**Re: Thor California, Inc. Recall
Defect and Non-Compliance Report**

THOR CALIFORNIA**RECALL SERVICE BULLETIN**

Ref. #: 150030

**Axle Spring Hanger Enhancement
(2-Axle Units Only)**

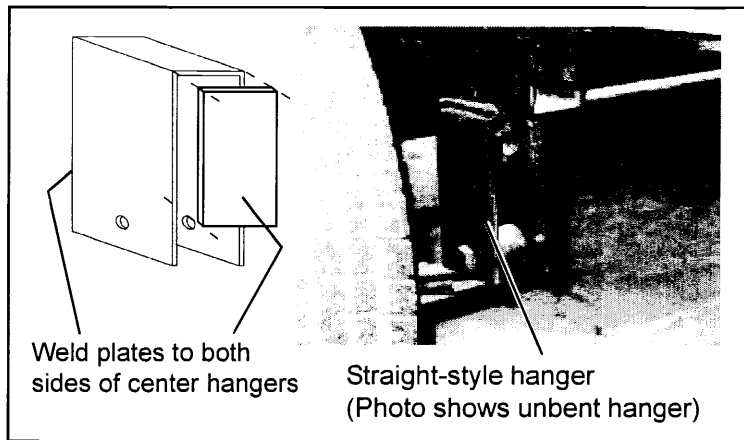
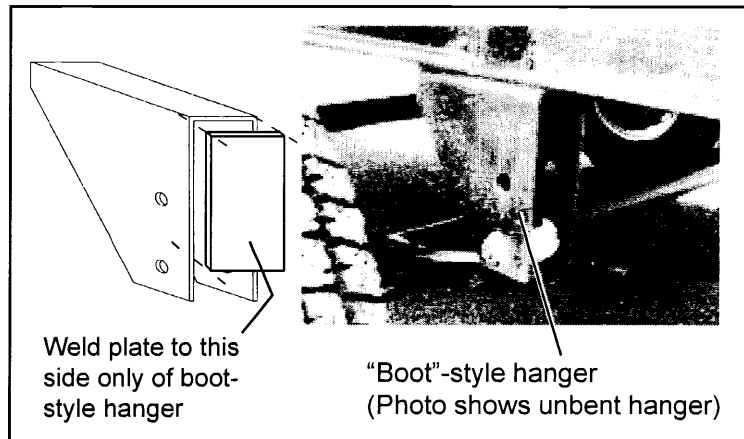
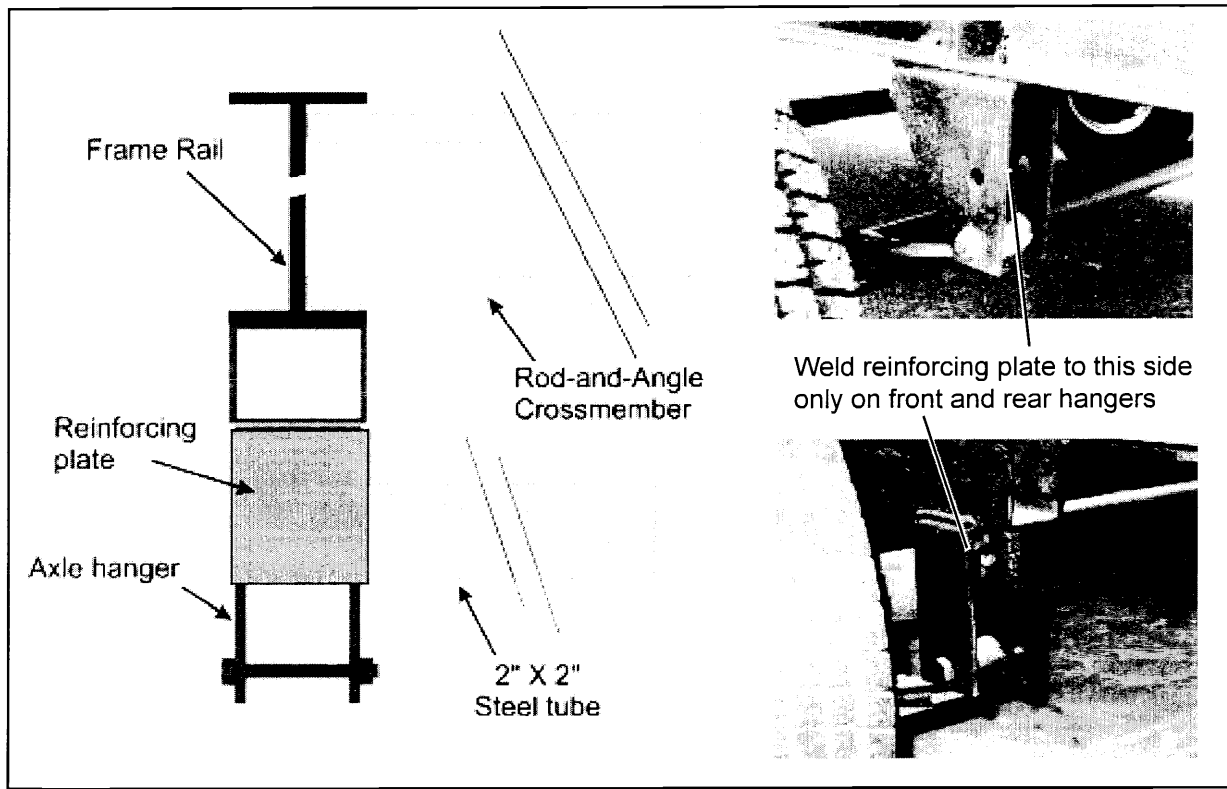
Under certain conditions, extreme side-loading of the axles may cause the axle hangers to become permanently bent. Repeated or extreme bending may also cause permanent bending of the frame rails, and misalignment of the axles and trailer chassis.

The procedure outlined in this bulletin adds reinforcing to the axle hangers and frame rails to improve their strength and minimize the potential of damage.

3. Straighten axle hangers as necessary. Reinforce the front and rear hangers by welding a $2\frac{3}{4}$ " X 4" X $\frac{1}{4}$ " steel plate to the the side of the hanger away from the axle. The plate should overlap the outside of the hanger by approximately $\frac{1}{8}$ " on each side. Reinforce the center hangers by welding $2\frac{3}{4}$ " X 4" X $\frac{1}{4}$ " steel plates to both sides of the hangers.

5. After all six hangers have been replaced or straightened and reinforced, weld the three 2" X 2" steel tube cross ties between the axle hangers. Trim the tube sections to fit as required.

6. Check between the main rails for the rod-and-angle crossmember within six inches of the rear hangers. If the crossmember is not installed, weld the new crossmember to the frame rail web as close as possible (within six inches) to the rear spring hangers as shown on the illustration on the last page.
